TECHNICAL BULLETIN
Bell Helicopter

No. 407-08-83

SUBJECT: ENCODING ALTIMETER RETROFIT

HELICOPTERS AFFECTED: 407 Helicopters having 407-706-001-101 kit installed.

Figure 1. Installation of encoding altimeter

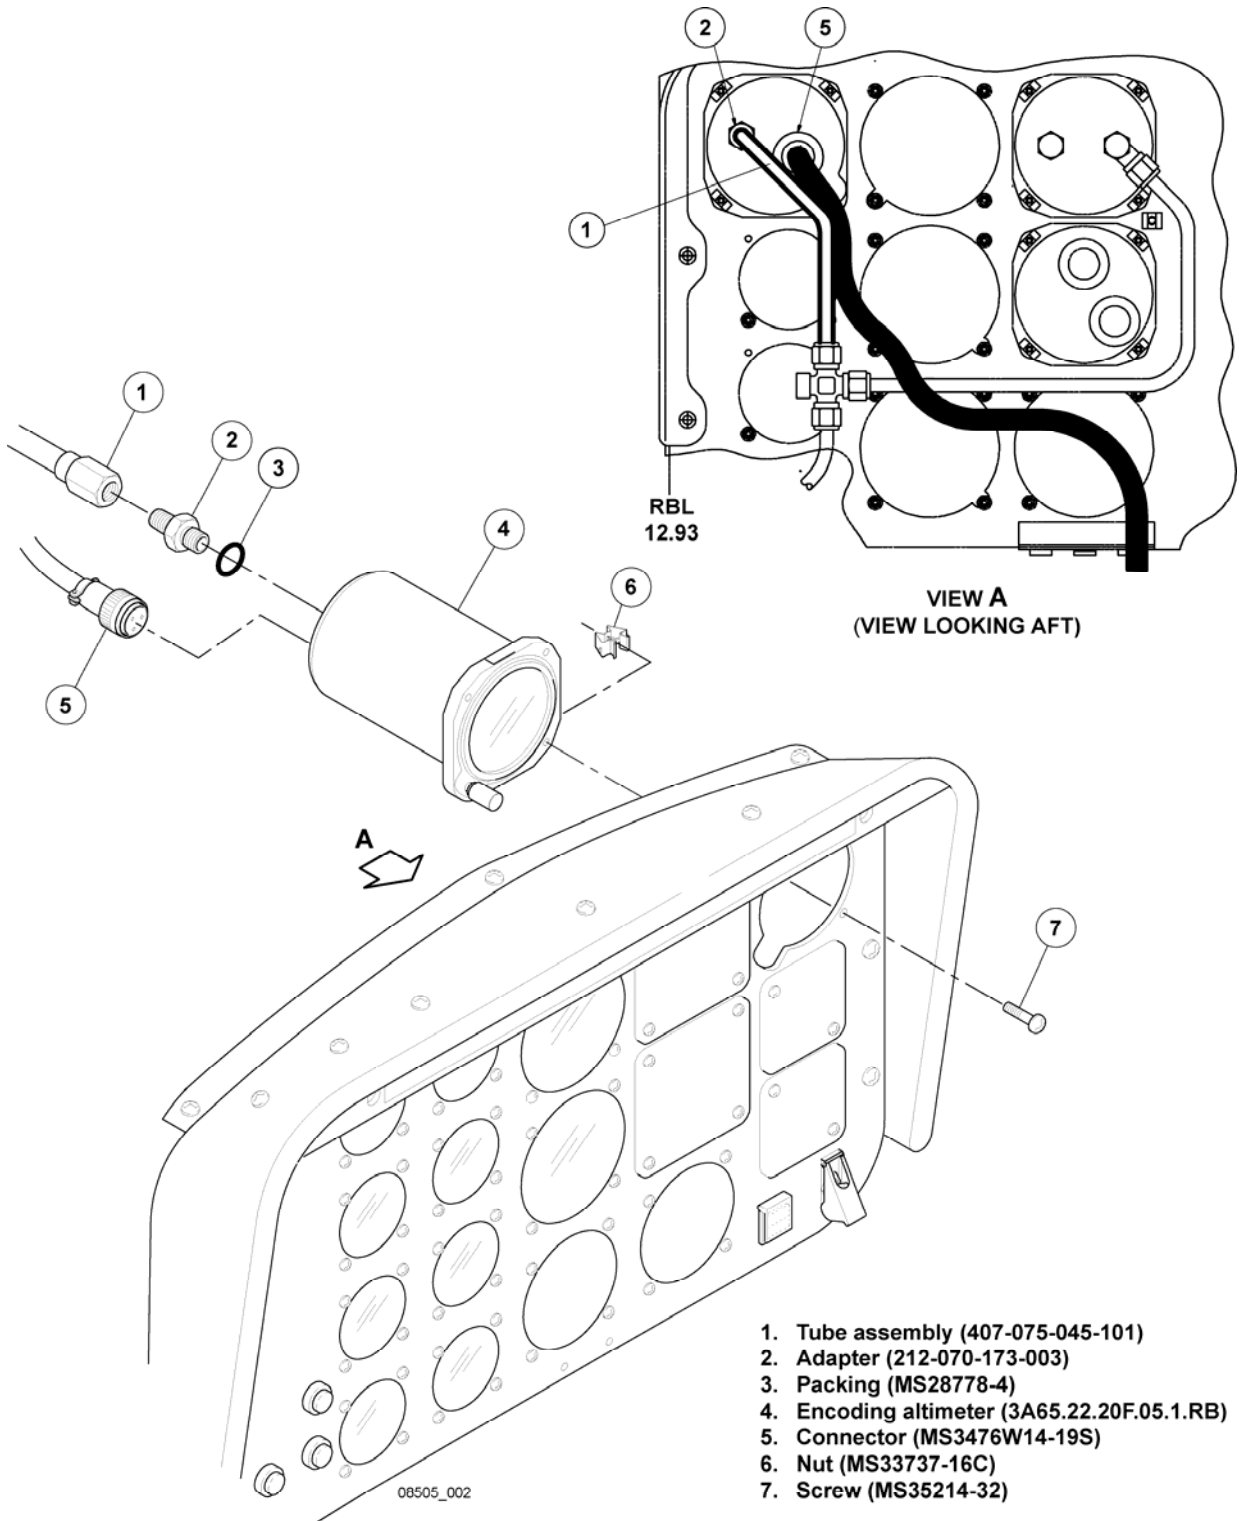
5. Remove existing encoding altimeter (refer to BHT-407-MM-10, chapter 95).
6. Remove and discard existing 407-075-028-101 static tube assy and existing 212-070-173-001 adapter (refer to BHT-407-MM-10 chapter 95 and BHT-407-IPB chapter 95).
7. Refer to figure 1, install packing (3) and apply 48 THD seal on adapter (2) side mating with encoding altimeter ensuring first thread to be free of tape.
8. Install adapter (2) into encoding altimeter (4).
9. Install the encoding altimeter (4) in its location on the instrument panel using nuts (6) and screws (7, previously removed).
10. Install 407-075-045-101 tube assy (1) between encoding altimeter adapter (2) and static port tee.

Figure 2. Encoding altimeter modified wiring diagram

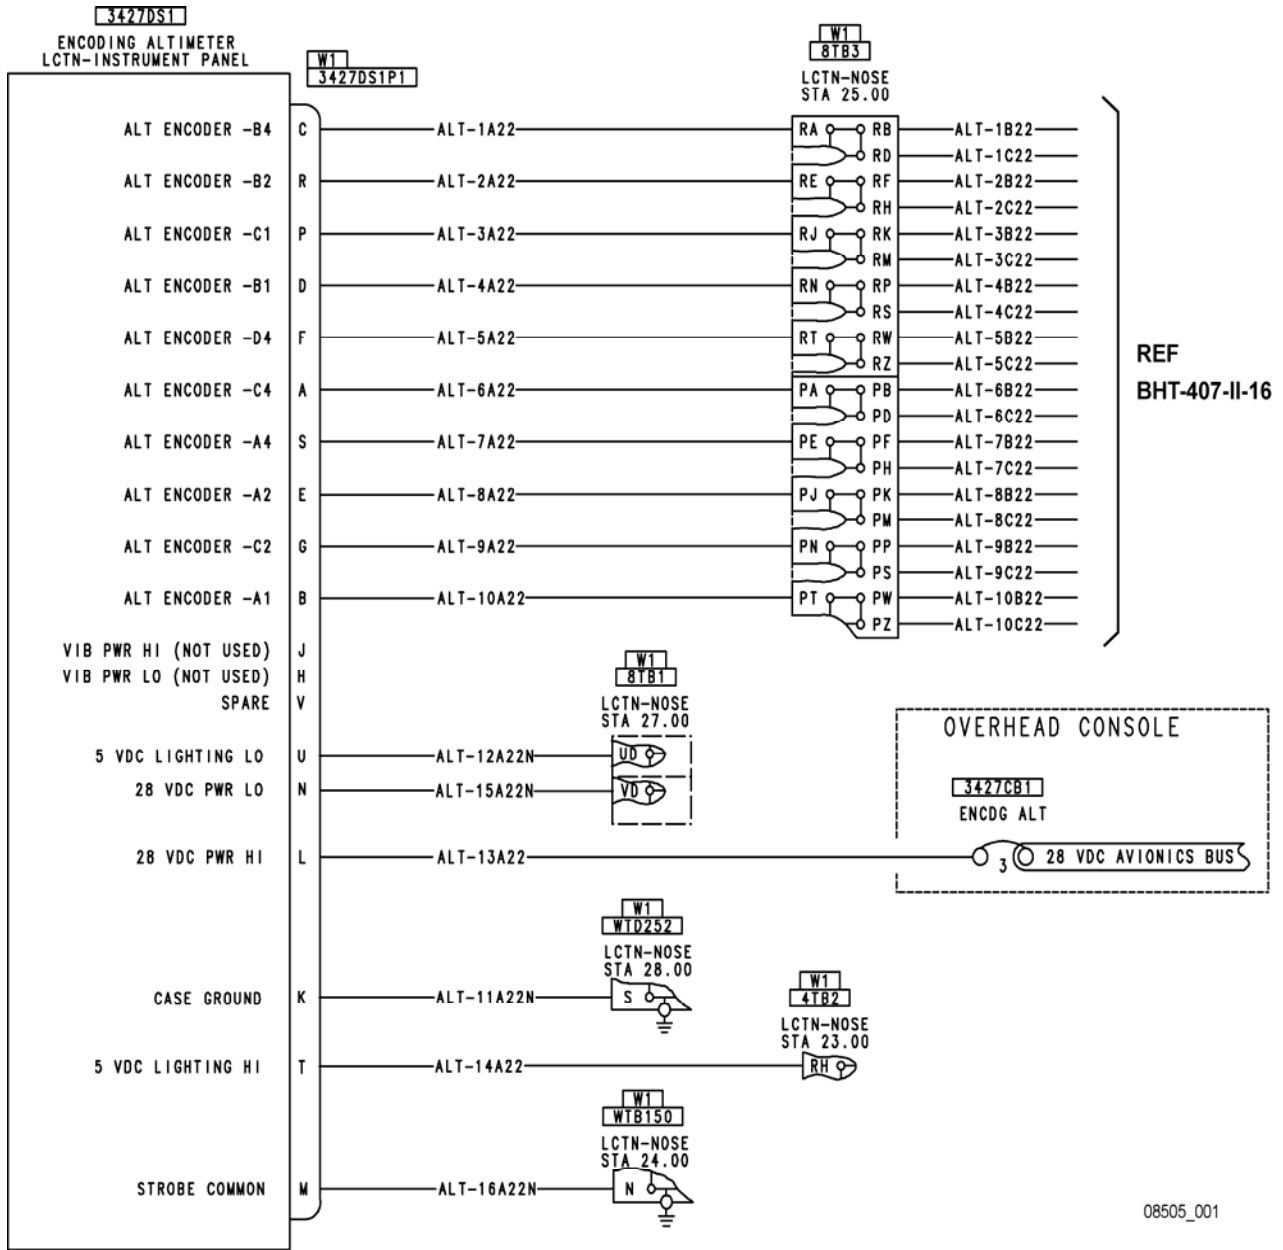
14. Add new wires as shown in figure 2 and figure 3, refer to figure 4 for the location of affected modules and terminal boards.
15. Re-terminate wires into new connector (ref. des. 3427DS1P1) as shown in figure 2 and figure 3.
16. Re-install the Pedal Restrictor Control Unit (ref des 6540CM1). (refer to BHT-407-MM-10, chapter 96)
17. Perform a pitot-static system leak test (refer to BHT-407-MM-10, chapter 95).
18. Perform a Pedal Restrictor Control Unit (PRCU) (ref des 6540CM1) operational check and functional test. (refer to BHT-407-MM-10, chapter 96)
19. Close instrument panel and re-install instrument pedestal panels. (refer to BHT-407-MM-10, chapter 95)
20. Make an entry in the helicopter records to show that this technical bulletin has been accomplished.
